mesa·az Planning and Zoning Board

GENERAL PLAN CASE #: ZON18-00181 (Minor General Plan Amendment)
ZONING CASE #: ZON18-00067 (Re-zoning and Site Plan Review)
LOCATION/ADDRESS: The 9500 thru 9800 blocks of East Hampton Road (south side).
GENERAL VICINITY: Located north of the US-60 Superstition Freeway and west of Crismon Road.
GENERAL PLAN REQUEST: Minor General Plan amendment to change Character Type from Employment to Neighborhood-Suburban.
ZONING REQUEST: Rezone from NC-BIZ, NC-PAD and PEP-PAD-CUP to RSL2.5-PAD and RM-3-PAD, and Site Plan Review; and consideration of the Preliminary Plat for “Bella Encanta”
PURPOSE: This request will allow for a small-lot, single-residence subdivision and multi-residence development.
COUNCIL DISTRICT: District 6
OWNERS: Crismon BFC LLC
APPLICANT: Pew and Lake, PLC
STAFF PLANNER: Lisa Davis, AICP

This site is located North of the US-60 Superstition Freeway and west of Crismon Road at the south side of Hampton Road. This is a request for Rezoning from NC-BIZ, NC-PAD and PEP-PAD-CUP to RSL-2.5-PAD and RM-3-PAD, Site Plan Review, and Preliminary Plat. The applicant proposes a 249-unit, small-lot residential and multi-residential development on 33±

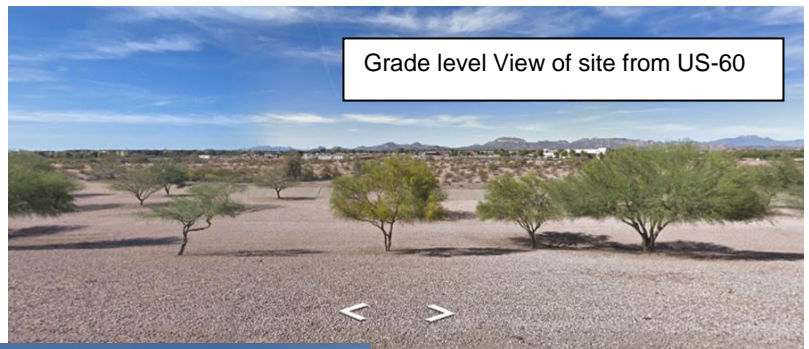
- Reduced front setback facing local street- The requested reduction from 20' to 10' could be supported by staff. Although, there is concern for adequate space for landscape. This will leave about 5' for landscape material. This is a concern since at least two of the seven units in each building is located adjacent to the street.

- Reduced side and rear setbacks-Staff is extremely concerned with the proposed 10' setback at the south property line for the condo product. The property line is adjacent to the ADOT channel and the US-60 at grade level beyond. The 10' setback is adjacent to living space with windows that will face the channel and freeway. With a 10' setback, there will not be adequate space between the buildings and the masonry wall for trees to be planted and survive, to provide the needed buffer.

95% of the residential projects adjacent to the US-60 in Mesa have a berm or sound attenuation wall, inset to the right, between the freeway and the residential projects but that is not occurring at this site.

If a residential project were to be constructed at this site, design of the development needs to include adequate buffering from the grade level adjacent US-60 freeway. The east side of the project does propose a 15' building setback adjacent to the PEP-PAD site and a 30' setback is required. Staff is concerned with sustainability and livability for the project and is not in support of this modification.

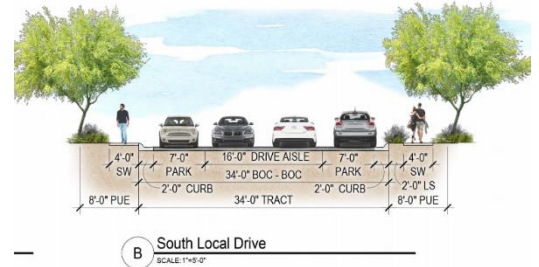
- The proximity to the US-60 Freeway, the adjacent Planned Employment Park to the east and Hampton Avenue have not been considered in the design of the project. Buffers from all have not been considered in the design.
- Solid Waste-The condominium units will have large bins for solid waste service. These bins are located adjacent to the small lot single residences and adjacent to the open space areas. The Mesa Zoning Ordinance (MZO) Section 11-30-12 provides standards for trash and refuse collection areas.

These standards include that the locations are reasonably equalized. Although the applicant shows that the bins are equally distributed, although far for the residents in the southern placed units. The placement of the bins adjacent to the small residential lots and next to the open space with residential houses and condos facing onto the areas are a concern. These areas can often become messy and unsightly. There is also concern for timing of the solid waste truck picking up the bins at 6 am adjacent to the homes. This is not a good design and is not supported by staff.
